EARLY DESIGN GUIDANCE OF THE WEST DESIGN REVIEW BOARD

Project Number: 3017320/ 3017321 (3017687 /3017686 for no-vacation options)

Address: 111 Westlake Ave N/ 110 9th Ave N

Date of Meeting: Wednesday, July 02, 2014

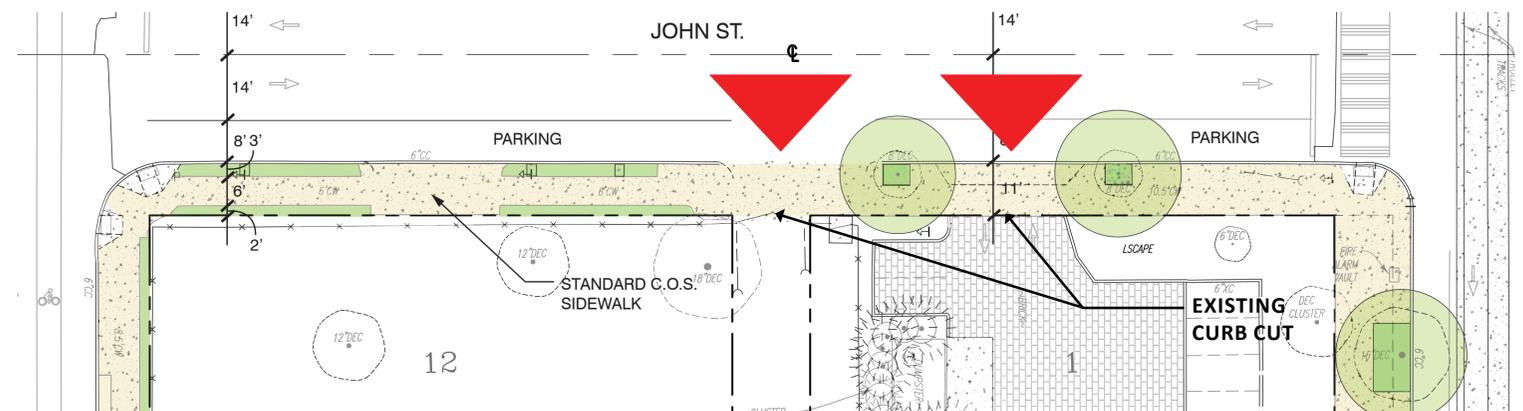
- a) The ramp location east of the alley and the proposed reduction in Green Street plantings for a right-turn lane (pg 72) appear to break the green street continuity too much, and crowd the pedestrian realm at the Westlake intersection; study shifting the ramp west of the alley, into the currently expansive residential ground floor.

- b) The proposed 40 ft curb cut (with or without the city required alley curb cut adjacent) presents pedestrian obstacles and breaks the green street, and the pedestrian experience along the ramp is poor; demonstrate why 3 lanes are needed when similar building densities use 1-2 (alley). Provide additional zoom in plans, sections and eye level perspectives of this open ramp, showing materials and all pedestrian views of it.

- c) Provide plans and perspectives of the singular ramp scheme which uses a standard alley curb cut, then 'goosenecks' into a parallel ramp to below. It is understood that the through-block connector may need to shift and consequently create departures; the DRB wishes to see that trade off.
